Support Document for the Revised National Priorities List Final Rule – Federated Metals Corp Whiting

**Support Document for the
Revised National Priorities List
Final Rule
Federated Metals Corp Whiting
September 2023**

**Site Assessment and Remedy Decisions Branch
Office of Superfund Remediation and Technology Innovation
Office of Land and Emergency Management
U.S. Environmental Protection Agency
Washington, DC 20460**

Figure 1 – Map showing the source areas at the Federated Metals Corp Whiting site (note: this is Figure 2 of the HRS documentation record at proposal for the Site).

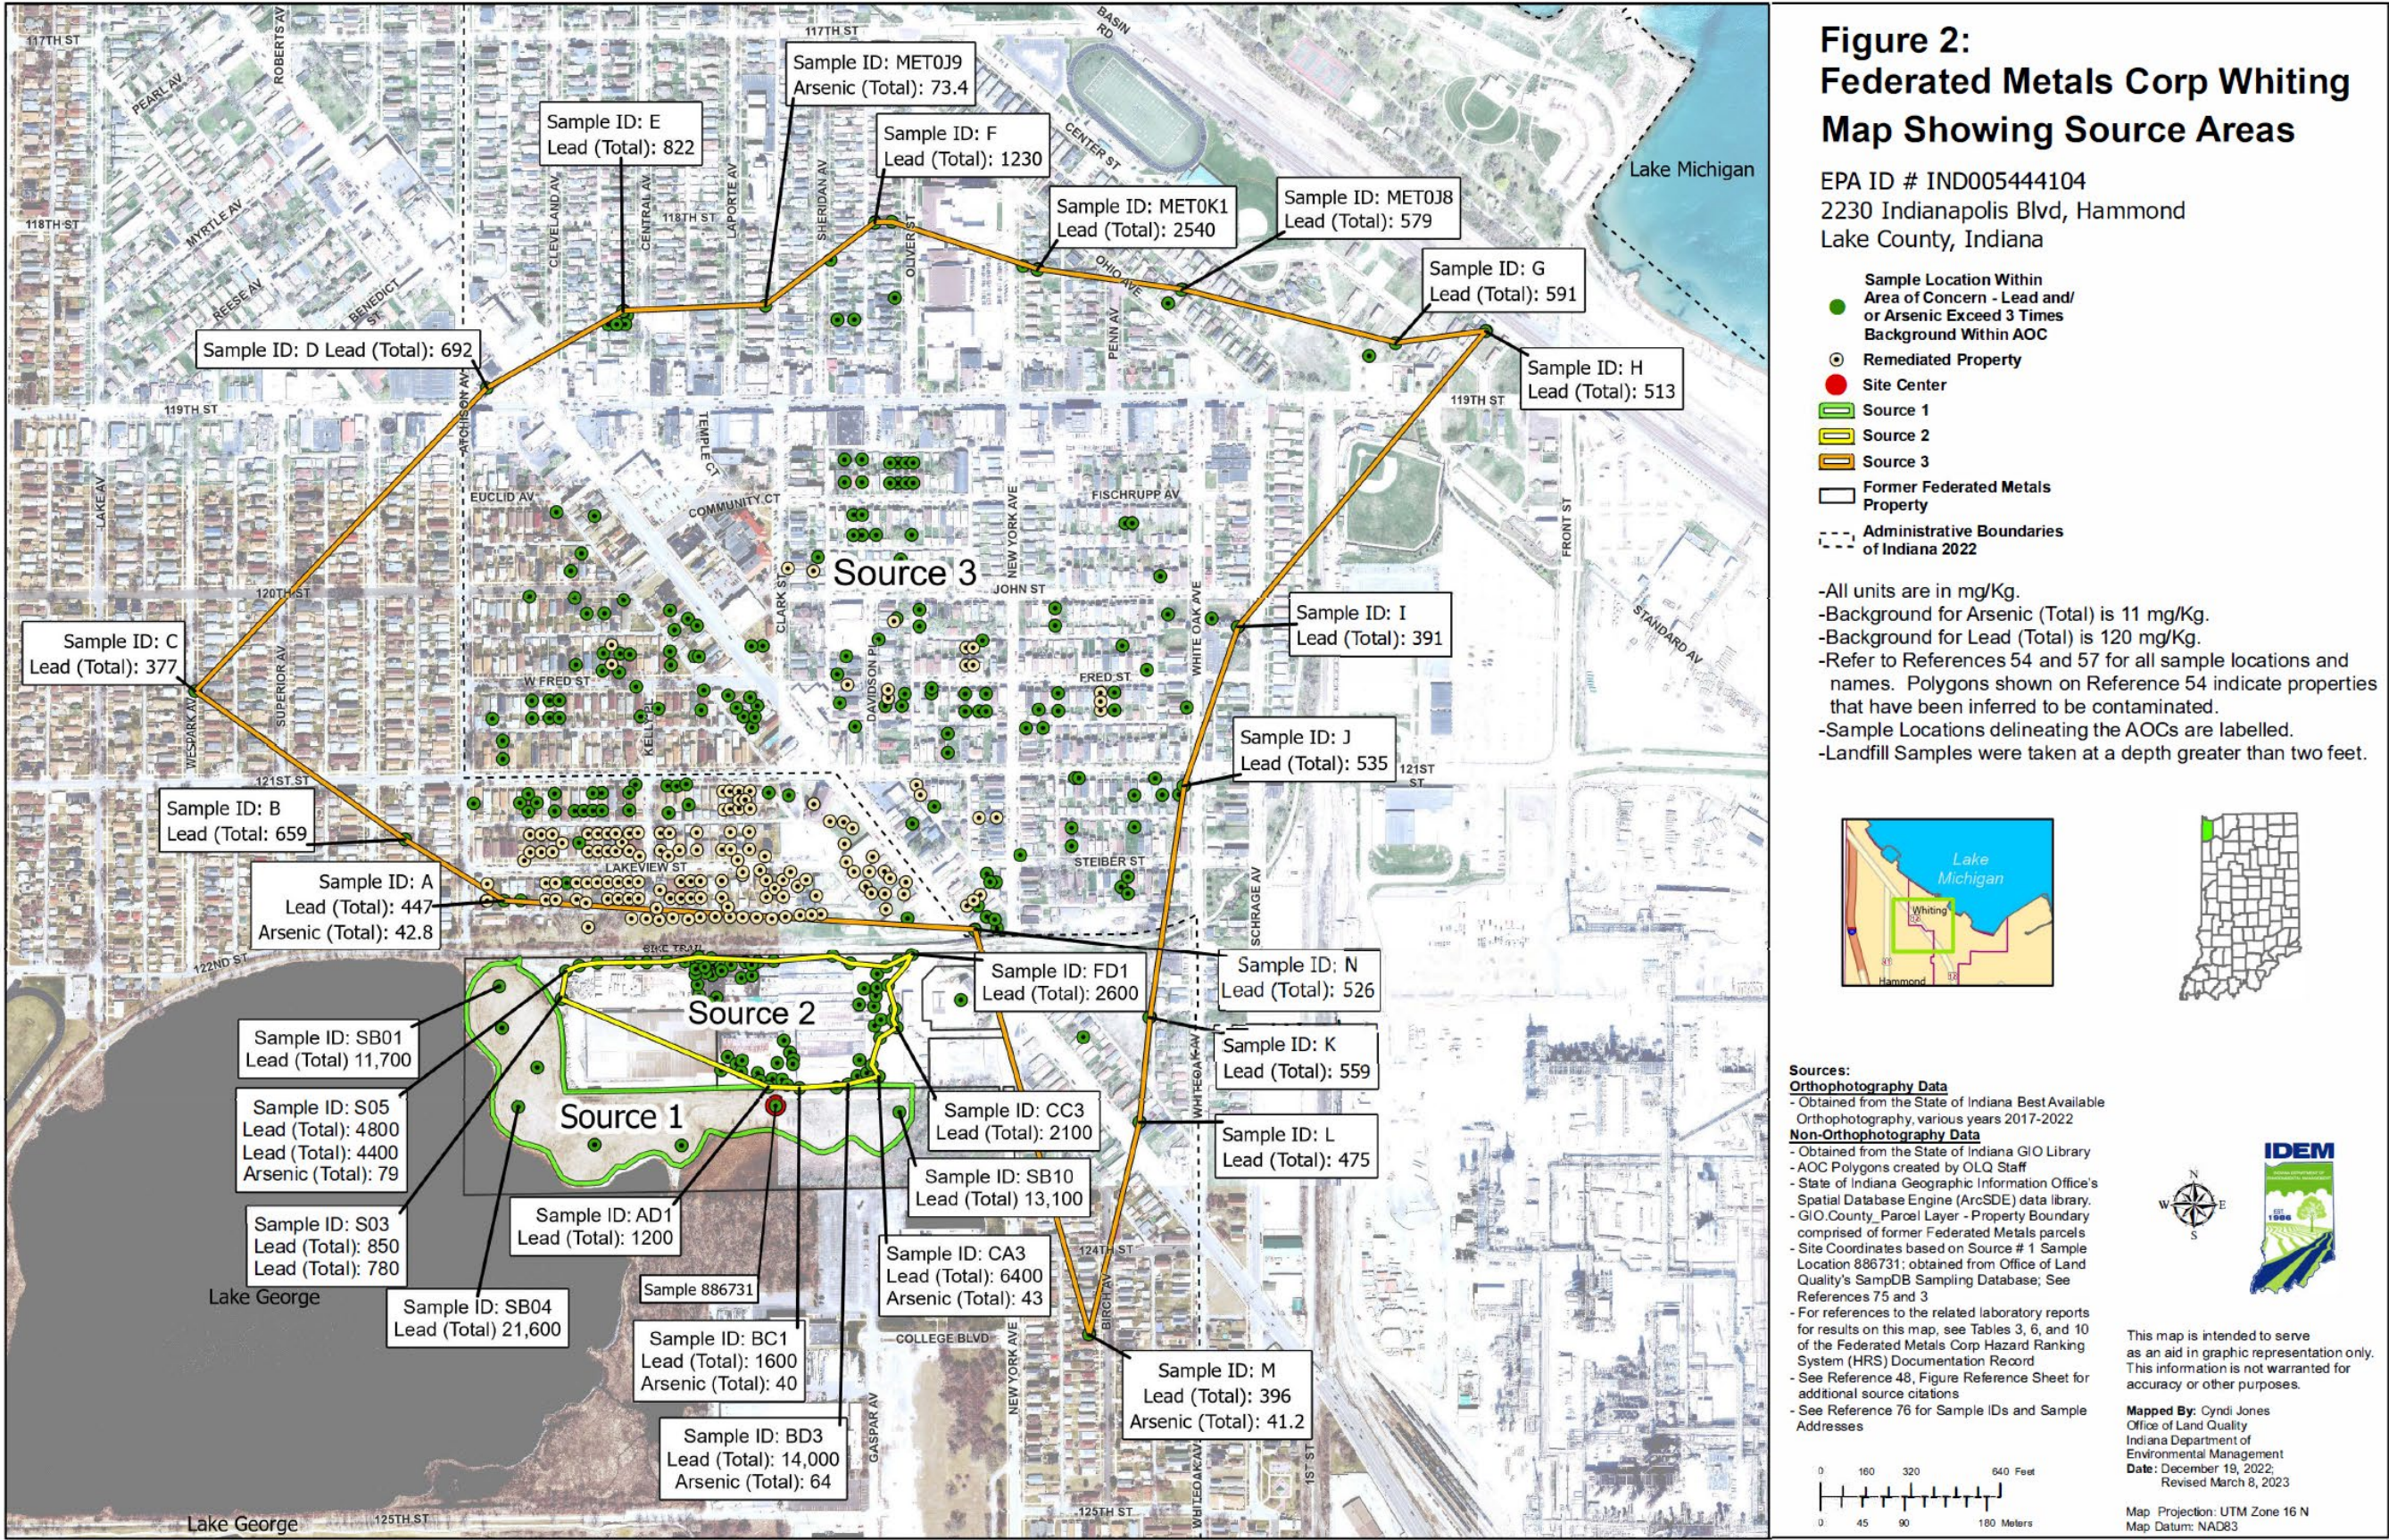
Comment: The Trust submitted comments related to whether the overland flow path for Source 1 and probable points of entry are accurately reported in the HRS documentation record at proposal. The Trust commented that the HRS documentation record at proposal misstates features on the Trust Property (Source 1) and notes that

Response: Inasmuch as these comments call into question the overland flow from Source 1 to surface water and probable points of entry (PPEs) to surface water, the description of the path that overland flow would take to enter surface water is correct in the HRS documentation record at proposal. Source 1 was found to be uncontained to prevent migration of hazardous substance from the source to surface water. See section 3.7, Containment-Source 1, of this support document. The HRS documentation record at proposal delineated a linear PPE to surface water into Lake George starting at the upper northwest corner of Source 1 down to the southeast section of Source 1. This PPE discharges into Lake George, which is directly adjacent to Source 1, and also discharges into the wetlands adjacent to the southeast section of Source 1, as exhibited on Figure 6 of the HRS documentation record at proposal. Further, by the Trust's own admittance, excess stormwater on the engineered cap is directed to two drainage swales that discharge to Lake George (at the northwest corner of the cap) and to the Sedge Meadow (wetlands) (at the eastern section of the cap); these discharges would also be considered part of the overland flow from Source 1 with PPEs into Lake George and the wetlands adjacent to Source 1.

The surface water pathway starts at the edge of the RCRA SWMU #1 (Source #1) which is the entire west and south portions of the former Federated Metals property. SWMU #1 (Source #1) is adjacent to Lake George and wetlands (Ref. 4, pg. 50; 38, pg. 21; Tables 15 and 19 of this documentation record; Figure 6 of this documentation record)....

#1 into Lake George. The PPE from Source #1 into the wetlands on the east side of Lake George [PPE 2 on HRS documentation record Figure 6] is also 0 feet (Tables 16 and 20 and Figure 6 of this documentation record; Ref. 27, pg. 17; 38, pg. 61).

Further, even if the EPA were to consider just the excess stormwater on Source 1 being directed to two drainage swales that discharge to Lake George (at the northwest corner of the cap) and to the Sedge Meadow (wetland) (at the eastern section of the cap) as stated in the Trust's comment letter, the site would still score sufficient for listing. That is, those two discharge points are PPEs from Source 1 to surface water. The discharge at the northwest corner of Source 1 into Lake George is part of the PPE denoted in the HRS documentation record at proposal; this location is part of the most upgradient section of the PPE as shown on Figure 6 of the HRS documentation record at proposal. The discharge into the Sedge Meadow (wetland) adjacent to the southeast corner of Source 1 is also part of the PPE denoted in the HRS documentation record at proposal; this location is part of the most downgradient section of the PPE as shown on Figure 6 of the HRS documentation record at proposal. The resulting in-water segments of the surface water migration pathway remain the same.
